# Metropolitan Planning Commission

## Staff Reports

**May 25, 2017**

**Proposed Site Plan**

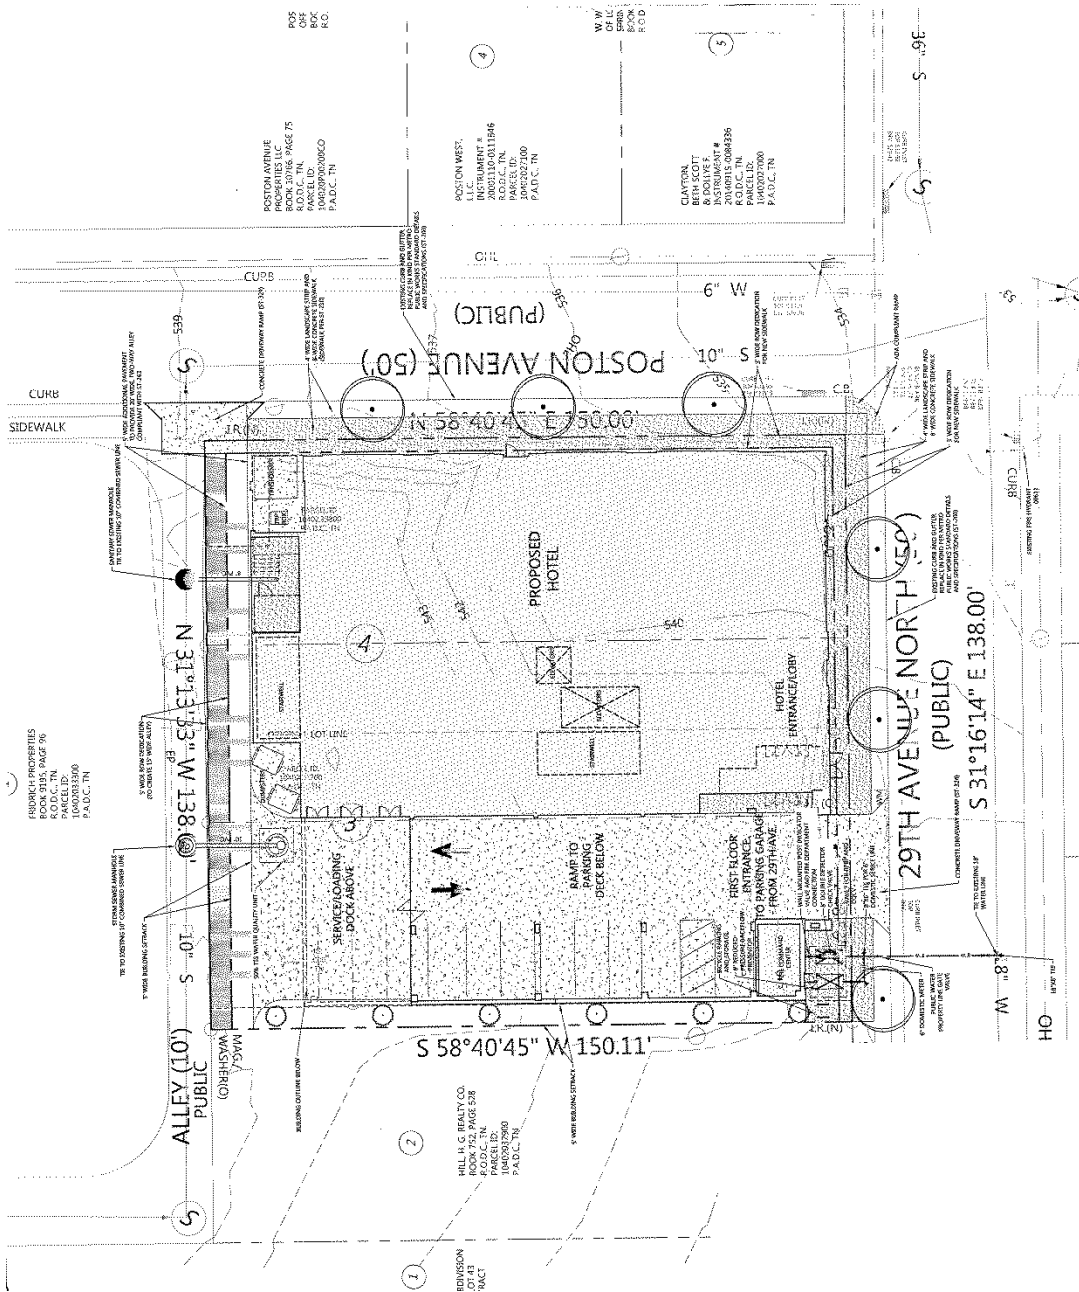
The revised preliminary SP does not include conceptual elevations. Elevations demonstrating that all facades are in compliance with the UDO standards will be required with the Final SP. The site plan shows a transformer located along the alley. All mechanical equipment is required to be screened per the standards of the UDO. The transformer shall be screened to the extent permitted by NES standards and requirements. The site plan indicates canopies that will extend over the sidewalk and into the right-of-way along 29<sup>th</sup> Avenue and Poston Avenue. Approval of a mandatory referral to permit the aerial encroachments will be required prior to building permits. Sidewalks which exceed Metro local street standards and meet the guidance for sidewalks adjacent to mid-rise or high-rise buildings in the Midtown Study are provided to enhance pedestrian connectivity in the area. Bicycle parking is provided consistent with Metro Zoning Ordinance requirements. No landscape buffer yards are required, but street trees and other landscaping are provided to enhance the pedestrian experience.

1. Permitted land uses shall be limited to a hotel with a maximum height of 90 feet as stipulated in the 31<sup>st</sup> Avenue and Long Boulevard Urban Design Overlay.
2. On the corrected set, update the Maximum FAR to 4.25.
3. Prior to use and occupancy permit, a mandatory referral approving aerial encroachments for the proposed canopies shall be approved by the Metropolitan Council.
4. Final architectural elevations for all facades of the building consistent all standards of the 31<sup>st</sup> and Long UDO shall be provided with the submittal of the Final Site Plan.
5. Comply with all conditions of Public Works and Traffic and Parking in regards to traffic improvements.
6. Final site plan review for the Specific Plan and 31<sup>st</sup> Avenue and Long Boulevard Urban Design Overlay shall be combined. All requirements of the Specific Plan and Urban Design Overlay shall be met.

### Proposed Site Plan

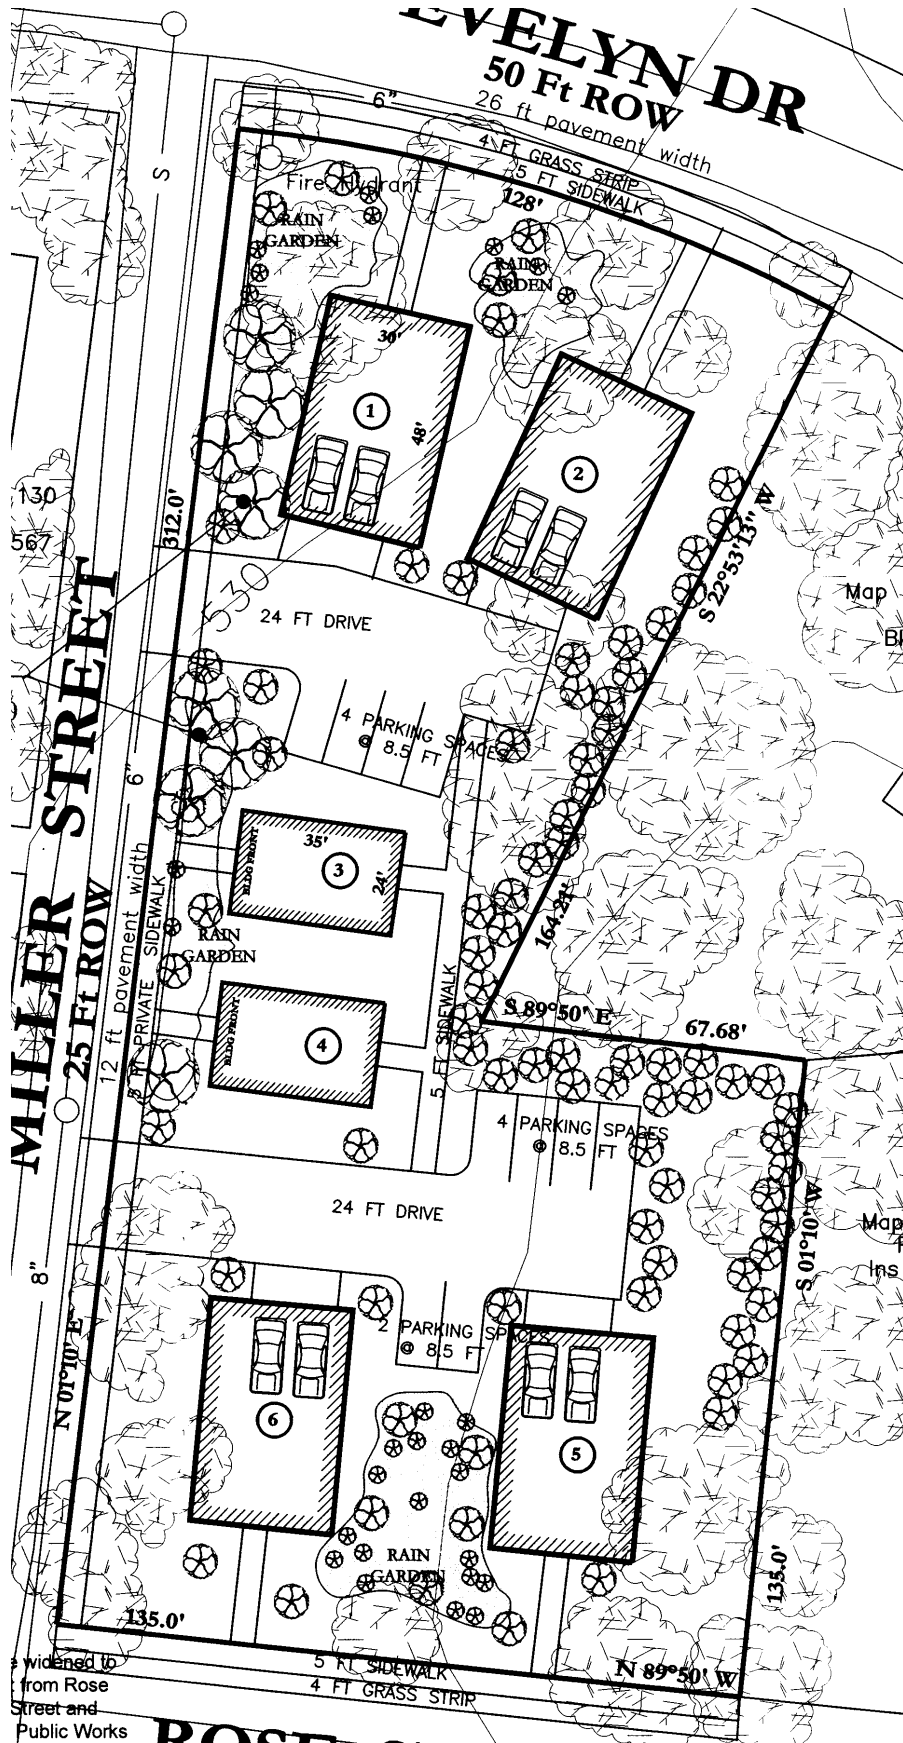
3. The final site plan shall add the following note to the internal private five-foot (5') north-south sidewalk on the west side of the site fronting Miller Street connecting to Evelyn Drive and Rose Street: five-foot (5') private sidewalk shall be maintained by the Homeowner's Association.

4. Provide a public pedestrian access easement for the sidewalk along Miller Street.
5. If a development standard, not including permitted uses, is absent from the SP plan and/or Council approval, the property shall be subject to the standards, regulations and requirements of the RM20-A zoning district as of the date of the applicable request or application. Uses are limited as described in the Council ordinance.

Proposed Site Plan

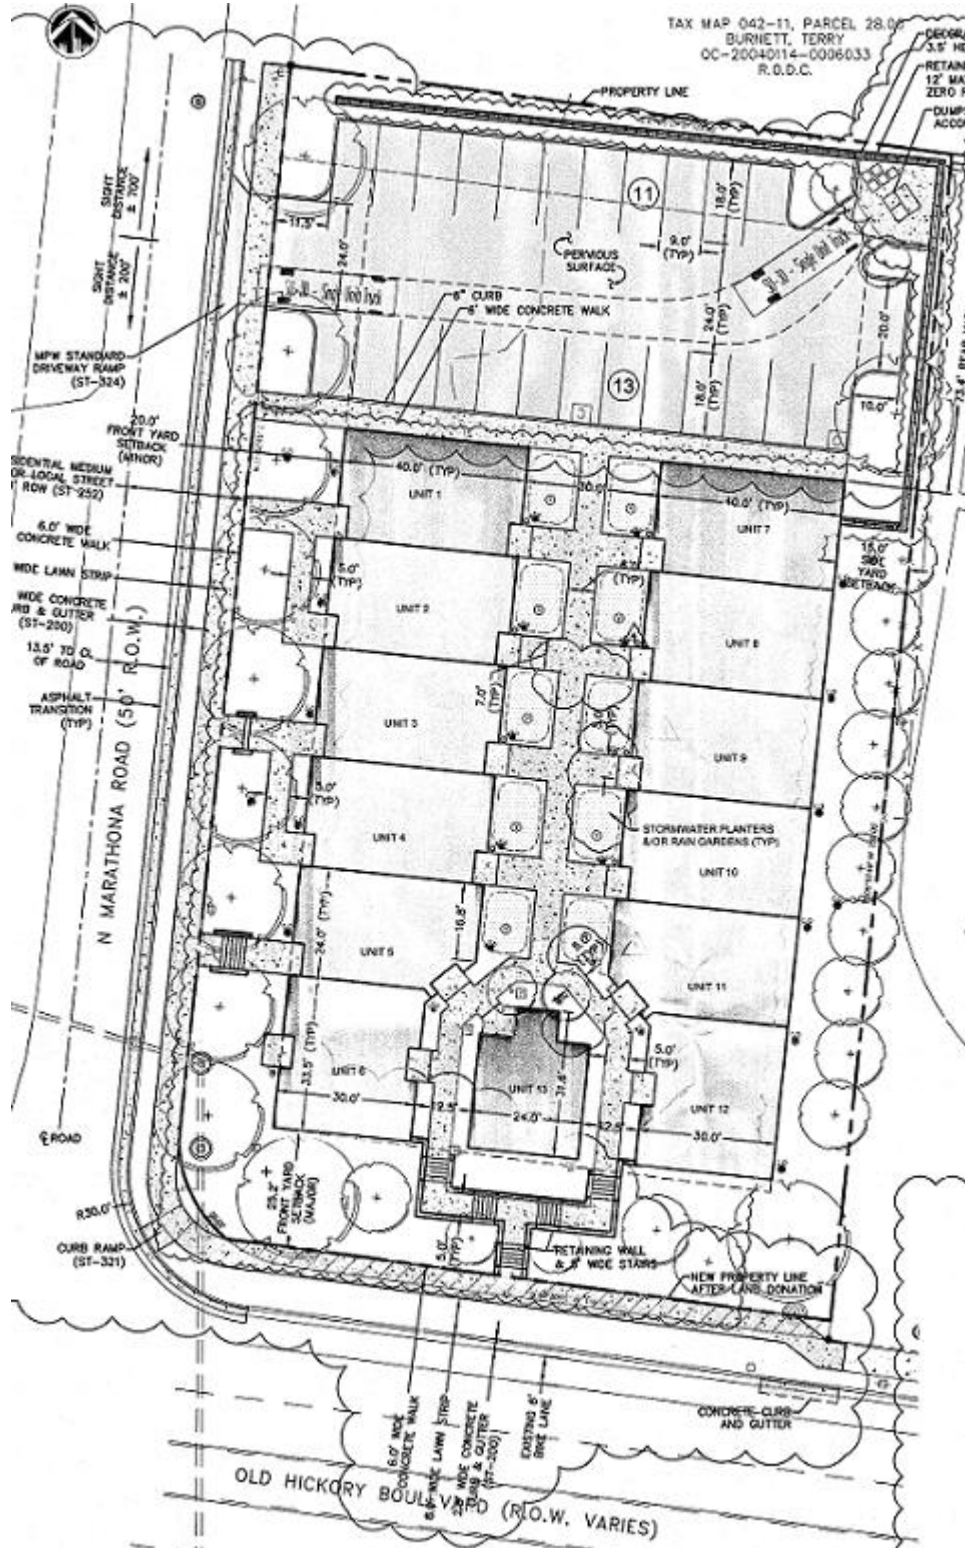
1. Uses in the SP shall be limited to a maximum of 13 multi-family residential units.
2. Multi-family parking requirements of the Metro Zoning Code must be met with the submittal of the final site plan.

5. The final site plan shall label all internal driveways as "Private Driveways". A note shall be added to the final site plan that the driveways shall be maintained by the Homeowner's Association.
